Submission by way of Objection

X/1578/2024
Macquarie Road and David Road
Springwood

Client: Springwood Residents Group
Revision 1.1

Figure 4-1 - Key heritage impacts

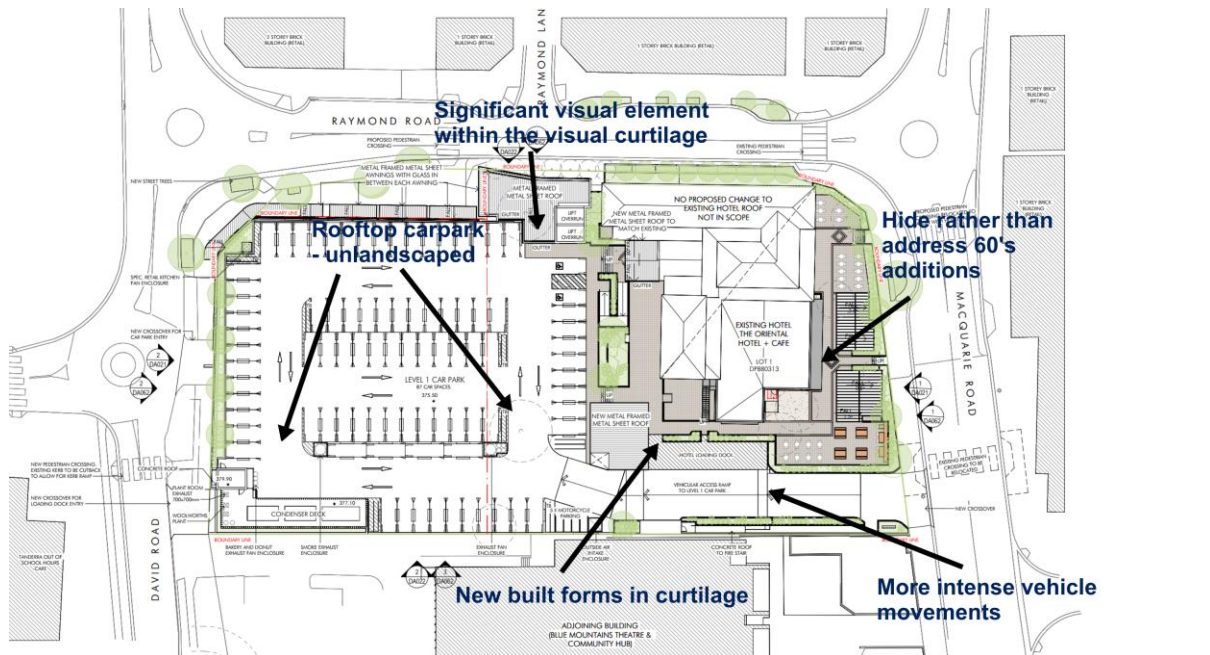
See comments on the heritage study. In brief, the proposal “crowds” the Hotel, and the extensive carparking with very limited vegetation does not provide a sympathetic curtilage to the Hotel. See figure below.

Figure 4-2 - Height limit breaches

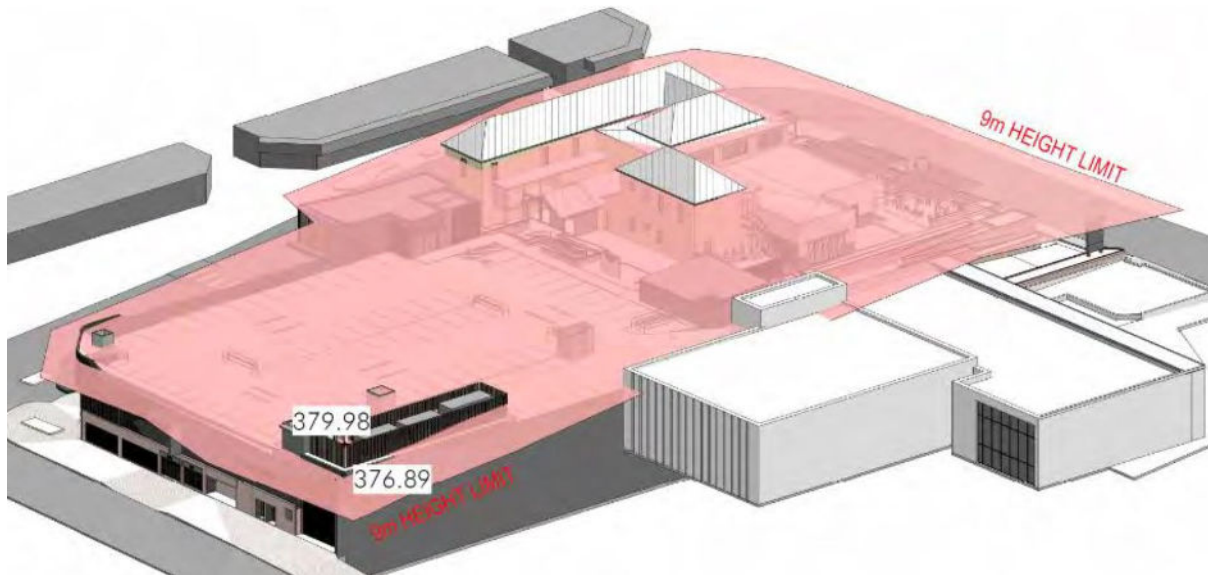
Comment: The development proposes a breach of building heights in two areas as outlined on the figure below. In the overall strategic context, however, these can be considered minor, although the architectural treatment of the breaches could be given further consideration, in particular noting the Springwood Masterplan intent to set back higher levels from the streetscape.
